## Technical Service Bulletin

<b>Topic</b>	Seat Belt Presenter - Intermittent Operation
<b>Market area</b>	Worldwide Bentley (1WBE)
<b>Brand</b>	Bentley
<b>Transaction No.</b>	2034323/3
<b>Level</b>	EH
<b>Status</b>	Released for publishing
<b>Release date</b>	Sep 12, 2013

Front seat belt system presenter intermittent in operation

Figure 1

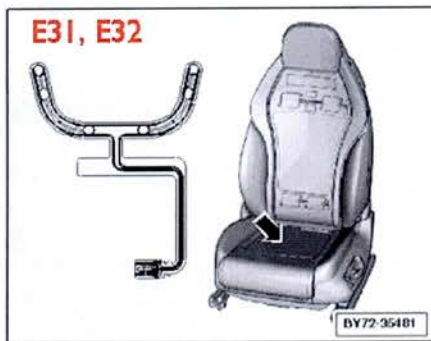
3. First check the occupancy sensor, E31, is function correctly (see Figure 1)

Figure 3

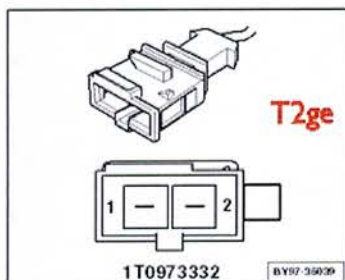
- With T2ge connector disconnected and an occupant sat in a natural position on the seat, with their back against the backrest, measure the resistance through the occupancy sensor (see Figure 3)

- If the resistance of the sensor with the seat occupied is greater than 90 Ohms then the sensor is faulty and should be replaced
4. Once the occupancy sensor is known to function to specification (operation 2) then remove and discard the original seat adjustment control unit with memory (J136 Drivers, J521 passengers) and replace with the latest level part (part number 4W0.959.760)
  5. The J136, J521 seat control unit is located under the seat frame reference workshop manual Rep. Gr.72 Front seat control unit (J136,J521) – To remove and fit
